UNITED STATES PATENT AND TRADEMARK OFFICE

10/673,643

Office Action Summary	Application No. 10/673,643	Applicant(s) MASSEY ET AL.	
	Examiner Gregory J. Strimbu	Art Unit 3634

- 1) ☒ Responsive to communication(s) filed on 07 April 2008.
- 2a) ☒ This action is **FINAL**. 2b) ☐ This action is non-final.
- 3) ☐ Since this application is in condition for allowance except for formal matters, prosecution as to the merits is closed in accordance with the practice under *Ex parte Quayle*, 1935 C.D. 11, 453 O.G. 213.

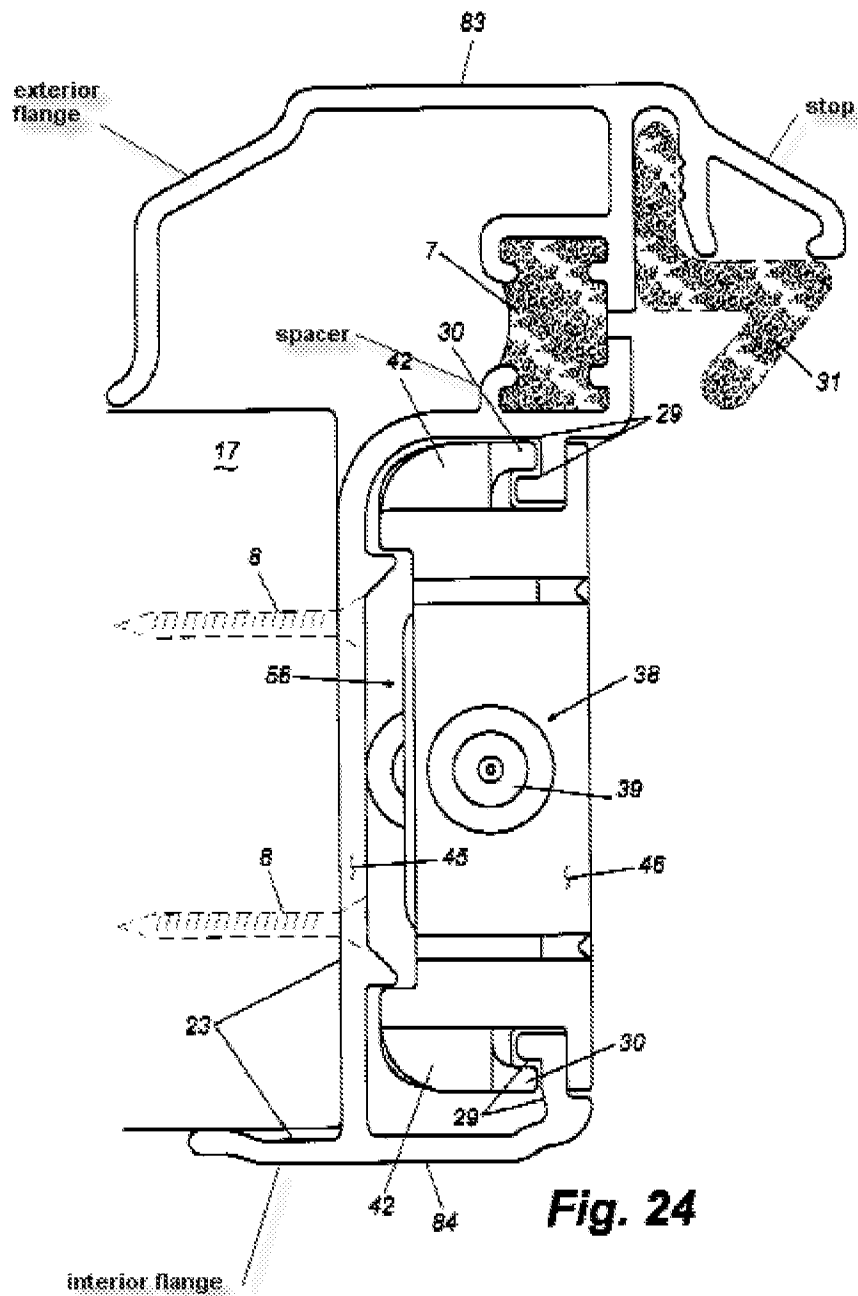
and Selzer (US 3491584). Massey et al. discloses an astragal assembly 27 for attachment to a passive door 17 having an interior surface, an exterior surface opposite to the interior surface, and an outer edge extending from the exterior surface to the interior surface, comprising: a frame 28 having an exterior portion 83, an interior portion 84 spaced from and opposed to the exterior portion, and a side portion 45 extending between the exterior portion and the interior portion disposed opposite the outer edge of the passive door when the astragal assembly is affixed thereto, a gasket 7 interconnected between said exterior portion and said side portion, an interior flange (labeled below) extending away from where said interior portion meets said side portion to engage the interior surface of the passive door when the astragal assembly is affixed thereto, and an exterior flange (labeled below) opposite said interior flange and extending away from where said exterior portion is connected to said gasket 7 to engage the exterior surface of the passive door when the astragal assembly is affixed thereto, wherein an elongated open channel is defined in the frame with sides formed by the exterior portion and the interior portion and a base formed by the side portion, the elongated open channel having an opening extending between the exterior portion and the interior portion and opposed to the side portion; and an insert 25 retained within the elongated open channel in the frame, a stop (labeled below), a second gasket 31, a thermal break 7, hooks 29, a strike plate 21. Massey et al. is silent concerning a spacer and an wooden insert.

However, Selzer discloses an astragal 80 comprising a spacer 82 having a distal end (not numbered, but shown in figure 2) protruding outwardly from a major surface

(not numbered, but shown in figure 2) of a side portion in a direction that is substantially parallel to an interior flange 83 and substantially perpendicular to said major surface.

It would have been obvious to one of ordinary skill in the art to provide Massey et al. with a spacer, as taught by Selzer, to maintain the astragal in good operative engagement with the door. See column 4, lines 50-56.

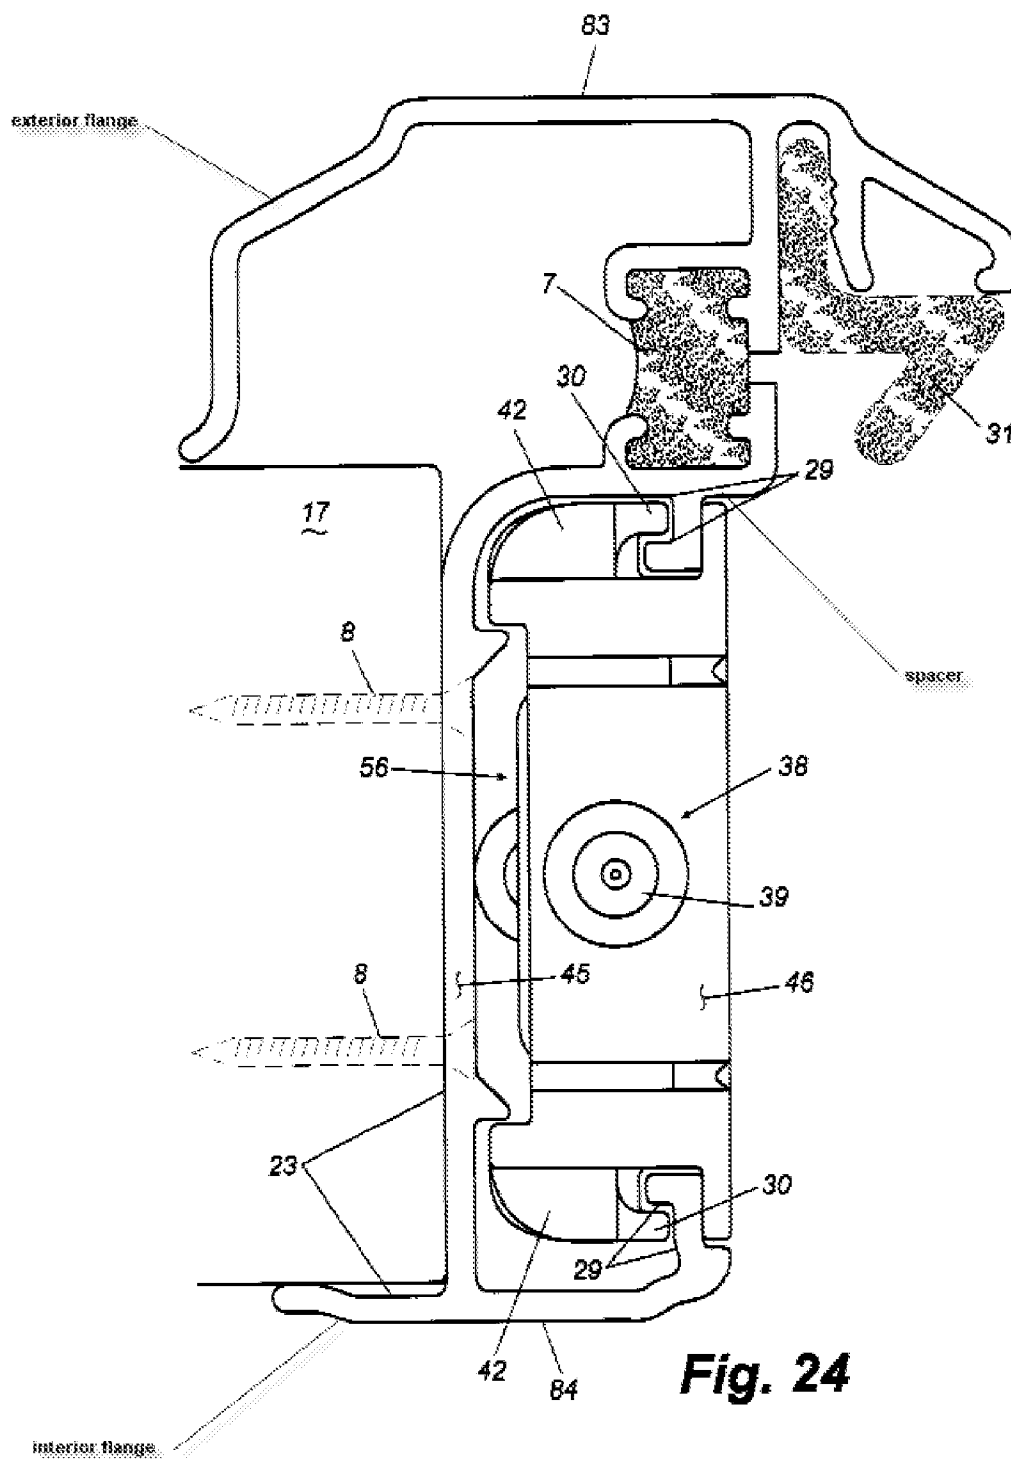
Claims 40, 46 and 48 are rejected under 35 U.S.C. 103(a) as being unpatentable over Massey et al. in view of Hendrickson et al. Massey et al. discloses an astragal assembly 27 for attachment to a passive door 17 having an interior surface, an exterior surface opposite to the interior surface, and an outer edge extending between the exterior surface and the interior surface, the assembly comprising:

surface of the passive door when the astragal assembly is affixed thereto, an interior portion 84 adjacent to the interior surface of the passive door when the astragal assembly is affixed thereto, a side portion 45 extending between the exterior portion and the interior portion of the metallic frame and opposite to the outer edge of the passive door when the astragal assembly is affixed to the passive door, a gasket 7 interconnected between the exterior portion and the side portion, an interior flange (labeled below) extending from where said interior portion meets said side portion to engage the interior surface of the passive door when the astragal assembly is affixed to the passive door, and an exterior flange (labeled below) extending from where said exterior portion is connected to said gasket to engage the exterior surface of the passive door when the astragal assembly is affixed to the passive door, the interior and exterior flanges spaced apart for accommodating an outer edge of the passive door therebetween, the interior portion, the exterior portion, and the side portion forming an opening in the metallic frame which faces away from the outer edge of the passive door when the astragal assembly is affixed thereto;

an insert 25 disposed in the metallic frame between the interior portion, the exterior portion, and the side portion thereof; and

at least one elongated spacer (labeled below) extending directly from said side portion and having a distal end that engages said insert, said at least one spacer maintaining said wooden insert in position within said opening;

further comprising a hardware component 46 disposed in the insert at the opening in the metallic frame;

wherein the interior flange and the exterior flange extend substantially perpendicular to a major surface of the side portion. Massey et al. is silent concerning a wooden insert.

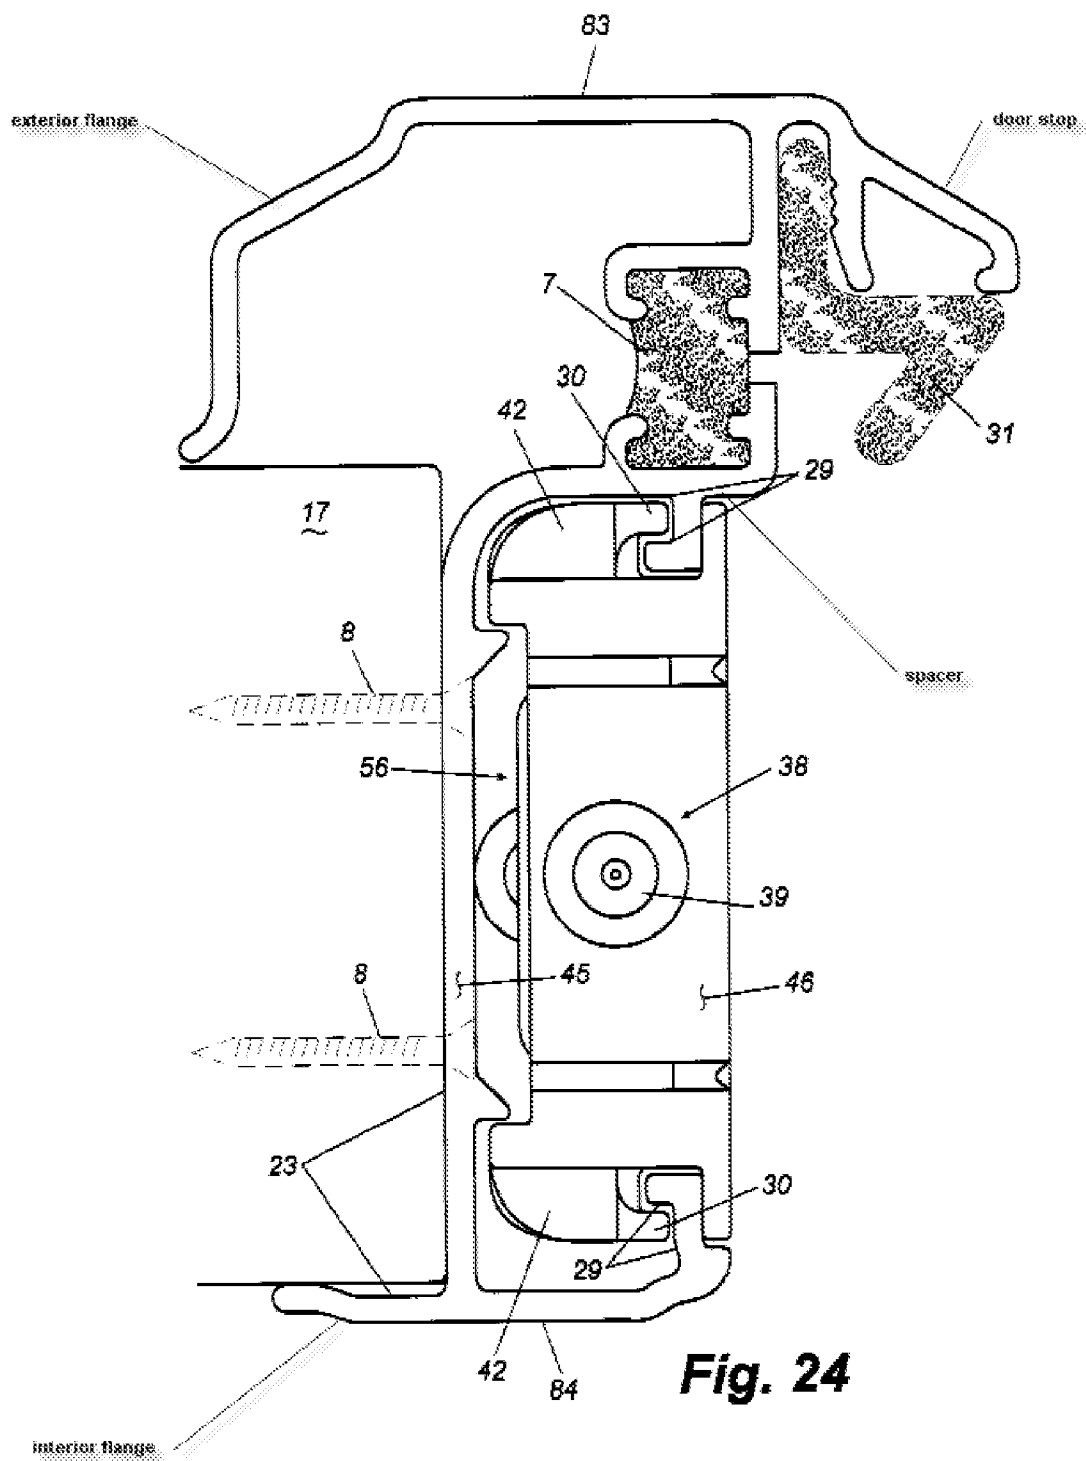
Claims 42 and 43 are rejected under 35 U.S.C. 103(a) as being unpatentable over Massey et al. in view of Selzer. Massey et al. discloses an astragal assembly 27 usable with an active door 18 and a passive door 17 having an exterior surface, an interior surface opposite to the exterior surface, and an outer end disposed between the exterior surface and the interior surface, the assembly comprising:

a frame 28 including an interior portion 84, an exterior portion 83 spaced apart from and opposed to the interior portion, a side portion 45 extending between the interior portion and the exterior portion opposite to the outer end of the passive door when the astragal assembly is attached thereto, a gasket 7 interconnected between the exterior portion and the side portion, an interior flange (labeled below) extending from

where the interior portion meets the side portion to engage the interior surface of the passive door when the astragal assembly is attached thereto, an exterior flange (labeled below) extending from where the exterior portion is connected to said gasket to engage the exterior surface of the passive door when the astragal assembly is attached thereto, a channel formed by the exterior portion, the interior portion, and the side portion of the frame, and a door stop (labeled below) extending from the exterior portion of the frame on the opposite side from where the exterior flange is located, said door stop for engaging the active door when the astragal assembly is attached to the passive door;

an insert member 25 disposed in the channel and having a surface exposed to the active door when the astragal assembly is attached to the passive door;

wherein the interior portion and the exterior portion extend away from the outer end of the passive door when the astragal assembly is affixed thereto, and said side portion is disposed opposite the outer end of the passive door when said interior and exterior flanges of the frame are disposed on the interior and exterior surfaces of the passive door, respectively;

the frame 28 is metallic. Massey et al. is silent concerning a spacer.
